UNITED STATES PATENT AND TRADEMARK OFFICE

APPLICATION NO.	FILING DATE	FIRST NAMED INVENTOR	ATTORNEY DOCKET NO.	CONFIRMATION NO.
10/589,547	08/16/2006	Andrew Clarke	88047TJS	8466
1333 7590 06/22/2010 EASTMAN KODAK COMPANY PATENT LEGAL STAFF 343 STATE STREET ROCHESTER, NY 14650-2201			EXAMINER MOON, SEOKYUN	
			ART UNIT 2629	PAPER NUMBER
			MAIL DATE 06/22/2010	DELIVERY MODE PAPER

Office Action Summary

DETAILED ACTION

Drawing 1

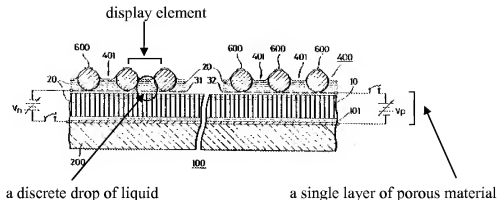
As to **claim 1**, Kohashi teaches a display element [drawing 1 provided below, which is same as figure 1 of Kohashi] comprising a single layer of porous material, a discrete drop of liquid and means ("*V_n*" or "*V_p*") for connecting a voltage supply to the layer, whereby an application of a voltage between the liquid and the porous layer, the drop of liquid moves into the layer [drawing 2c and col. 3 line 65 – col. 4 line 5], the drop moving back out of the layer upon removal of the voltage [drawing 2a and col. 3 lines 28-35], the movement of the liquid effecting an optical change when viewed from above the porous layer.

Kohashi does not teach the layer comprising a plurality of conductive particles covered with a lyophobic and electrically insulating covering.

However, Lin teaches the concept of including a plurality of conductive particles [col. 2 lines 34-38] in a layer of a display [col. 2 lines 26-38].

It would have been obvious to one of ordinary skill in the art at the time of the invention to include the plurality of conductive particles of Lin in the layer of Kohashi, in order to allow the layer of Kohashi to display different colors.

Kohashi as modified by Lin does not expressly teach that the plurality of conductive particles is covered with a lyophobic and electrically insulating covering.

However, Examiner takes Official Notice that it is well known in the art to cover particles with a polymer to prevent the particles from coagulation.

Therefore, it would have been obvious to one of ordinary skill in the art at the time of the invention to modify the display element of Kohashi as modified by Lin to cover each of the particles with a polymer, in order to prevent the particles from coagulation.
